**DEFENSE NUCLEAR FACILITIES
SAFETY BOARD**

Staff Report

SUBJECT: Transuranic Waste Facility Documented Safety Analysis Development Review

Figure B-1. *Empirical vs. Predicted Heat Flux Values (Source: SFPE Handbook, 3rd Edition, 2002 [B-3])*

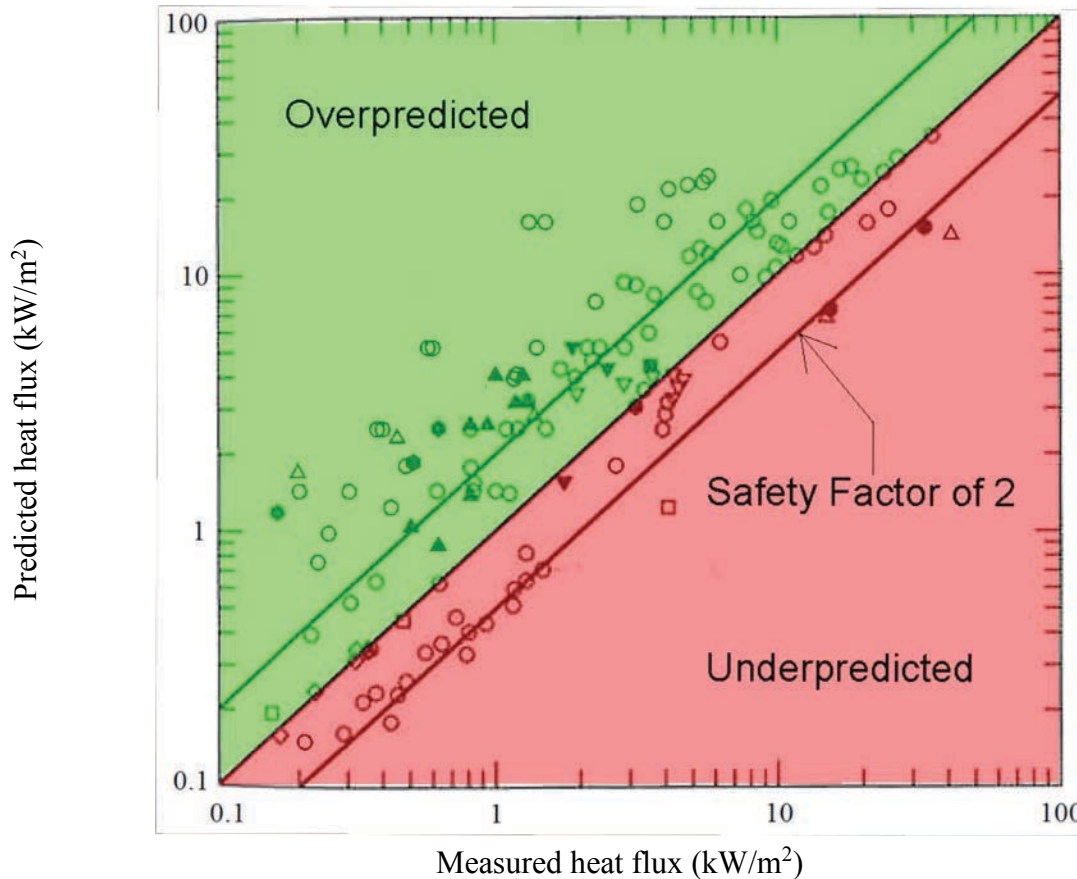
The non-conservatism relates to the use of an appropriate safety factor in the Mudan and Croce method, which is used to determine the fire separation distances in a LANL calculation applied to TWF (hereafter referred to as the "LANL calculation") [B-2]. The Mudan and Croce method, which is described in the Society of Fire Prevention Engineers (SFPE) Handbook [B-3], estimates the radiant heat flux to a target from a source fire. The separation distances are calculated by determining the minimum separation distance between and RFP and MAR that prevents development of radiant heat fluxes associated with waste drum seal failure or lid loss. The SFPE Handbook recommends that a safety factor of two be used with this method:

Figure B-1 shows the predicted and measured heat fluxes from the Mudan and Croce method. Note that without the safety factor, there are a number of data points where the Mudan and Croce method under predicts the radiant heat flux. Using a safety factor of 2 ensures that nearly all of the data points fall in the over predicted region. The LANL calculation [B-2] does not appear to incorporate an explicit safety factor as suggested by the method, and no discussion of this safety factor is provided in the calculation.

Figure C-12. CFAST Results - Maximum column temperatures with varying fire ventilation

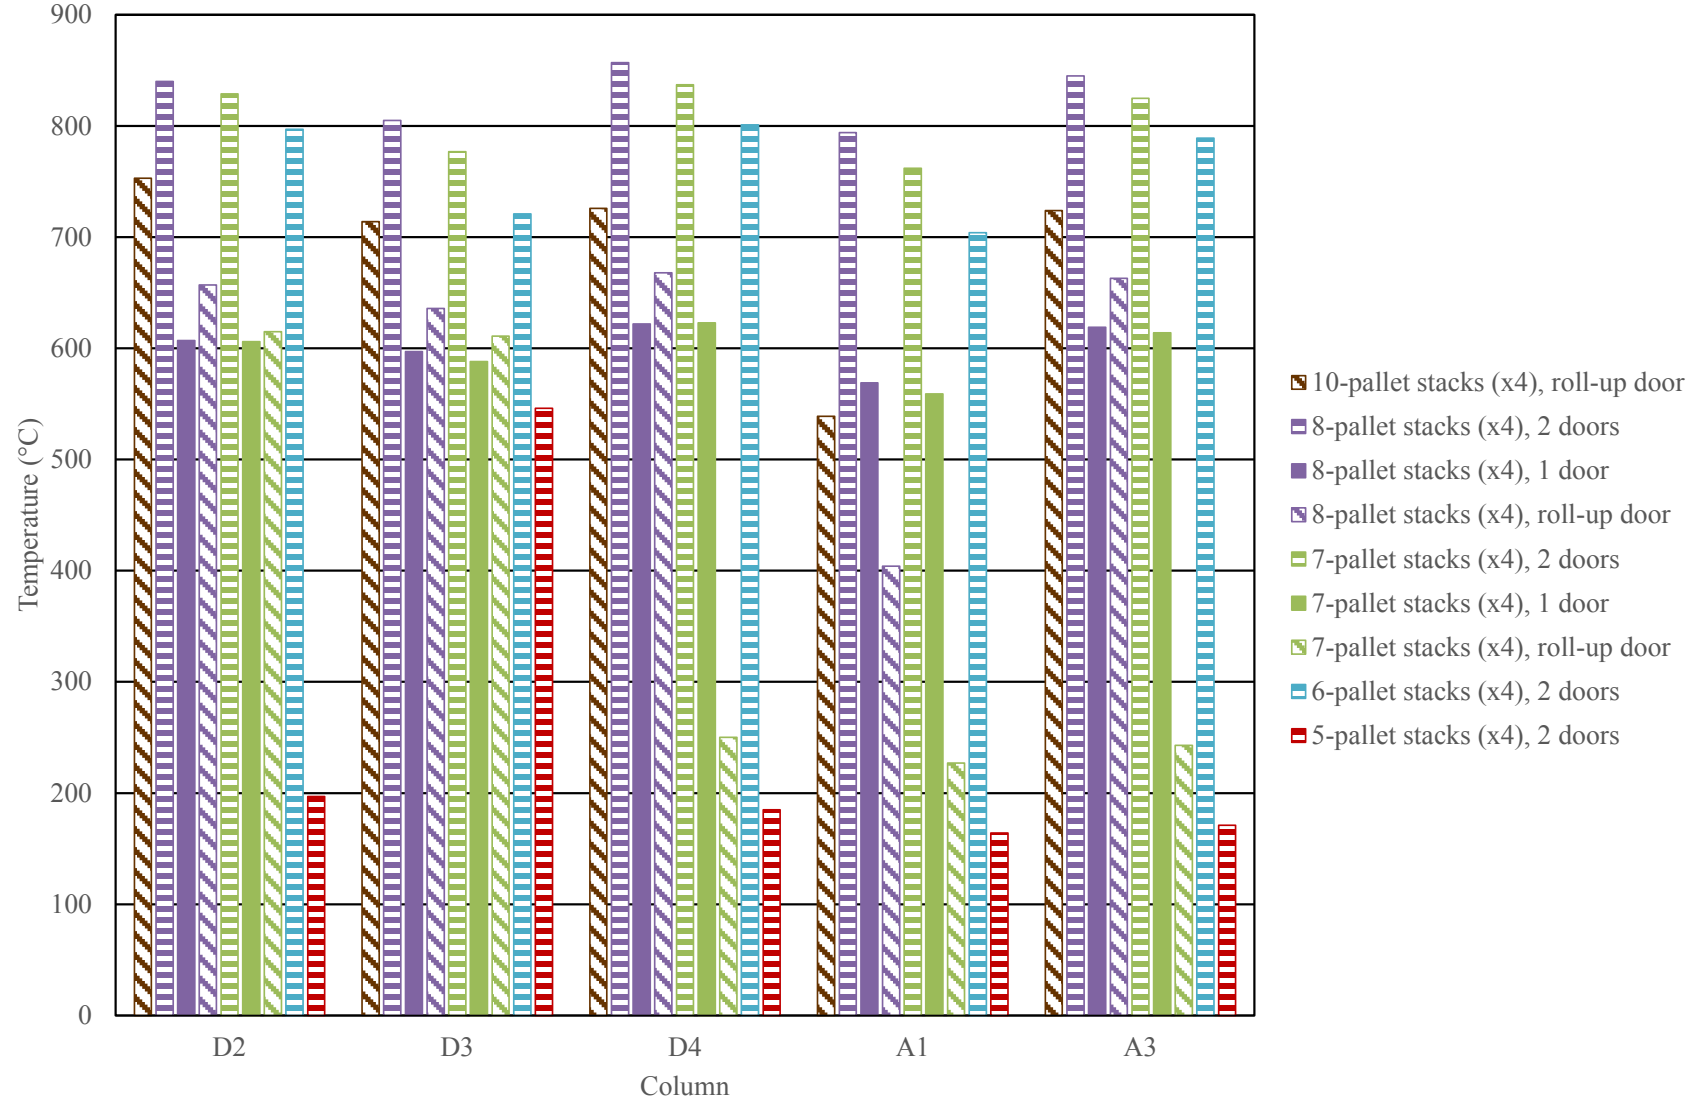
Figure C-12 shows the maximum column temperatures reached under the varying ventilation conditions considered in this evaluation. As seen in the figure, only scenarios with two personnel doors open consistently result in column temperatures well above 700 °C (1290 °F), and then only with six-high pallet stacks or more. The only scenarios where the maximum temperature of column A1 is above 700 °C (1290 °F) are the six-, seven-, and eight-pallet stack scenarios with two personnel doors open. This is the only column considered in the model that does not have an adjacent pallet stack fire, and is the column most remote from the fires. When the combustible load with two doors open is reduced to five-pallet stacks, only the initial pallet stacks burns and the maximum column temperatures at those stacks only get to about 550 °C (1,022 °F).

Figure C-13. CFAST Results - Maximum column temperatures with two personnel doors open

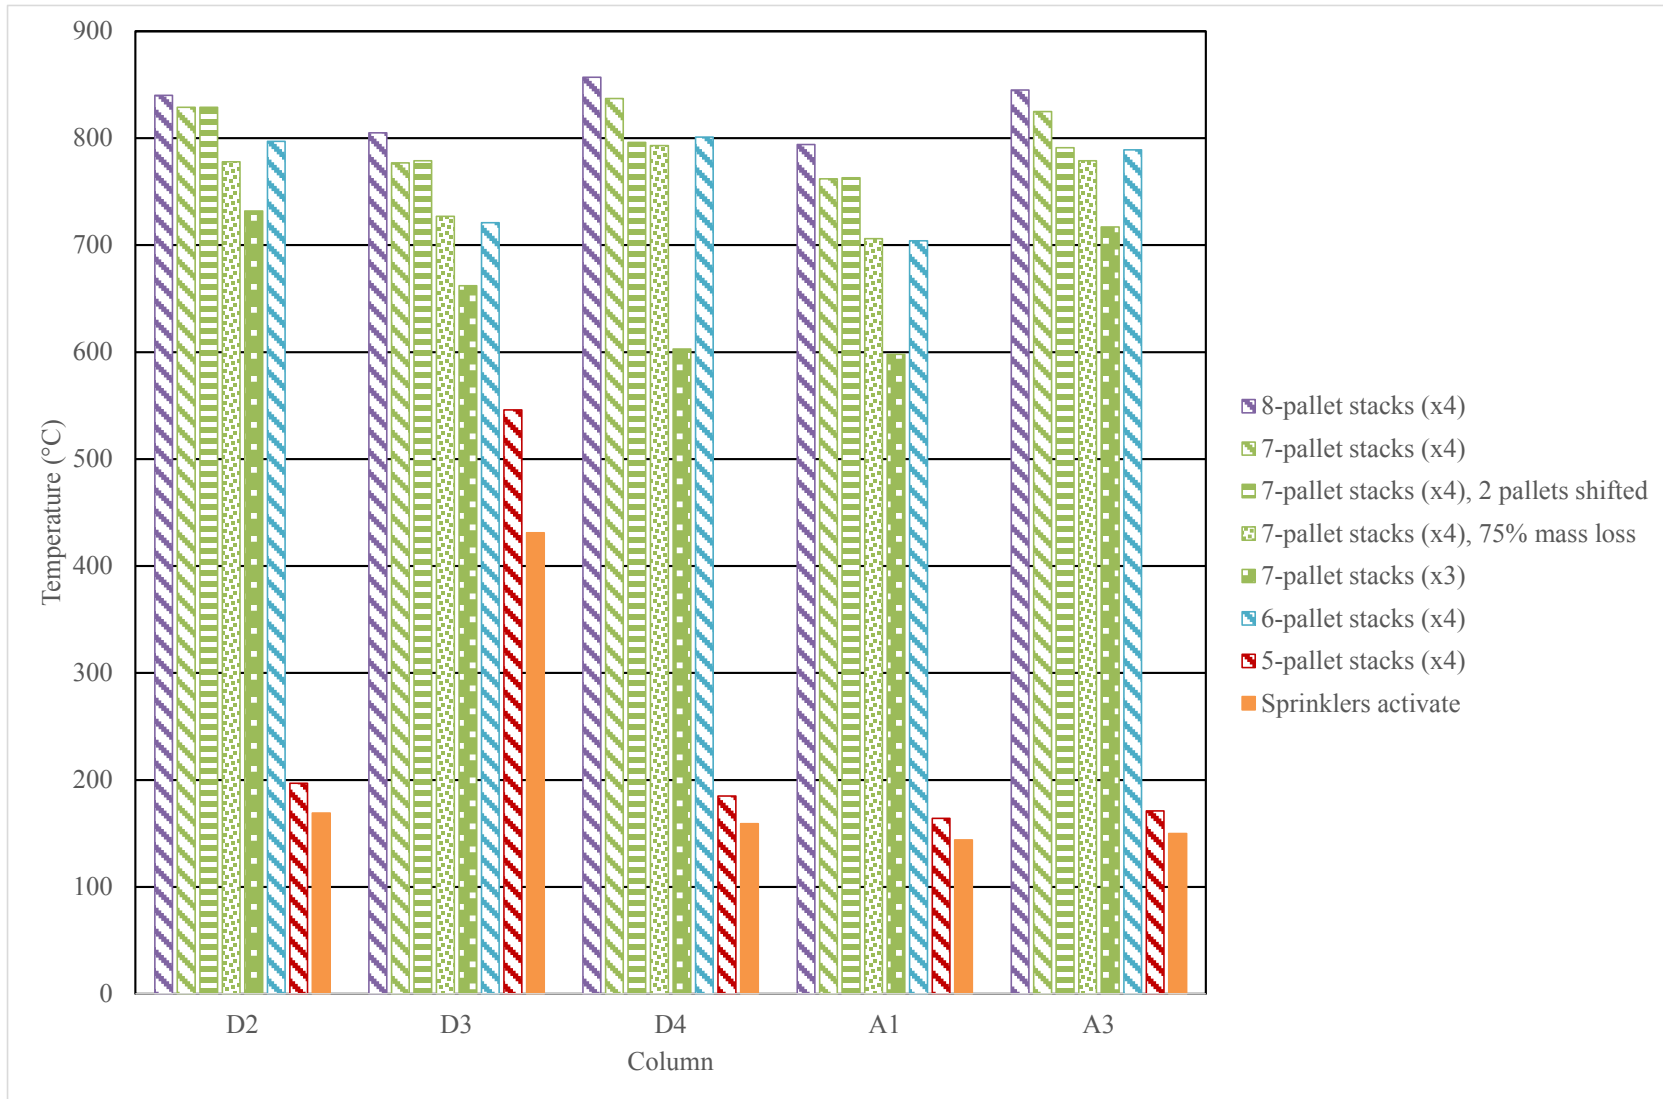
Figure C-13 shows the results of scenario variation with two personnel doors open. The four pallet stack scenarios with five-, six-, seven-, and eight-pallets each are repeated for clarity in this figure. One additional scenario considers only three stacks of seven pallets each, where the pallet stack at column D4 is not included. In this scenario the other two pallet stacks still ignite, but the column temperatures are significantly lower than when four stacks are included. Excluding column D4, the average reduction in column temperature with three stacks is 18 percent. In the three-stack scenario, only two columns are above 700 °C (1290 °F).

A second scenario variation considers moving the pallets 0.3 m (1.0 ft) away from the columns. This change lowers the intensity of radiation received at the column from the fire. Moving the fires at columns D4 and A3 reduces the peak column temperature by about two percent.
